## Luminant Energy Tyler 345/138 kV Autotransformer Project Comment Form

Date	10/2/2007
Name	Michael Juricek
E-mail Address	Michael.Juricek@oncor.com
Company	Oncor Electric Delivery

Date	10/10/2007
Name	Michael Juricek
E-mail Address	Michael.Juricek@oncor.com
Company	Oncor Electric Delivery (Oncor)

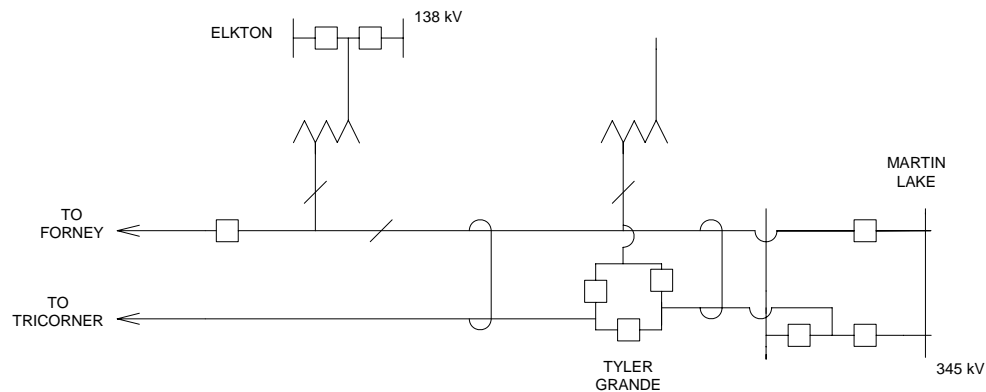
Oncor Electric Delivery (Oncor) supports Luminant Energy's (Luminant) proposal for an additional 345/138 kV autotransformer in the Tyler Area. In addition to the contingency discussed in Luminant's proposal, there are other contingencies of concern. The system protection relays on the Martin Lake – Shamburger 345 kV line will remove both the line and the 345/138 kV autotransformer at Shamburger from service for a fault on the line or in the autotransformer. This contingency during summer 2009 conditions will cause a 102% loading on the Elkton 345/138 kV autotransformer. The outage of the Shamburger autotransformer with the 345 kV line in service will load the Elkton autotransformer to 99% of its emergency rating.

The projected 2009 summer peak load for the Tyler Area is about 745 MW. This area is served by the 345/138 kV autotransformers at Elkton and Shamburger, five 138 kV lines and one 69 kV line. If 345/138 kV autotransformers are out of service concurrently during summer load conditions, multiple 138 kV and 69 kV lines will overload as much as 198%, and the voltage will drop to the point of most likely causing a local voltage collapse. The 138 kV and 69 kV systems can support only about 50% of the load in the area.

The City of Tyler is encircled by 138 kV lines. The 138 kV loop is supported by the 345/138 kV autotransformer at Elkton on the southwest and the 345/138 kV autotransformer at Shamburger on the northeast. The proposed location for the third autotransformer is the southeastern part of the City under a 345 kV line from Martin Lake. Oncor believes the reliability to be gained by placing the third autotransformer in a location different from the existing autotransformers is justified by the extremely serious impact of losing the existing two autotransformers concurrently. The original proposed location was to be the existing Tyler SE Switching Station. The City has started a road widening project which will prevent the expansion of Tyler SE. Land is available near Tyler SE for a new switching station to be called Tyler Grande.

Oncor proposes using a spare 493 MVA autotransformer at Tyler Grande. Our studies indicate this autotransformer will be capable of withstanding the contingencies of concern. The outage of the Martin Lake – Elkton 345 kV line also removes the Elkton 345/138 kV autotransformer from service because the autotransformer is connected on the line side of the 345 kV breaker at Elkton (See diagram below.). Leaving this autotransformer out of service reduces the loading on the autotransformer at Tyler Grande because it prevents power from flowing through the autotransformers and 138 kV lines to get from Tyler Grande back to the 345 kV system at Elkton. The use of an existing autotransformer also reduces the cost of the project which will be discussed in detail later.
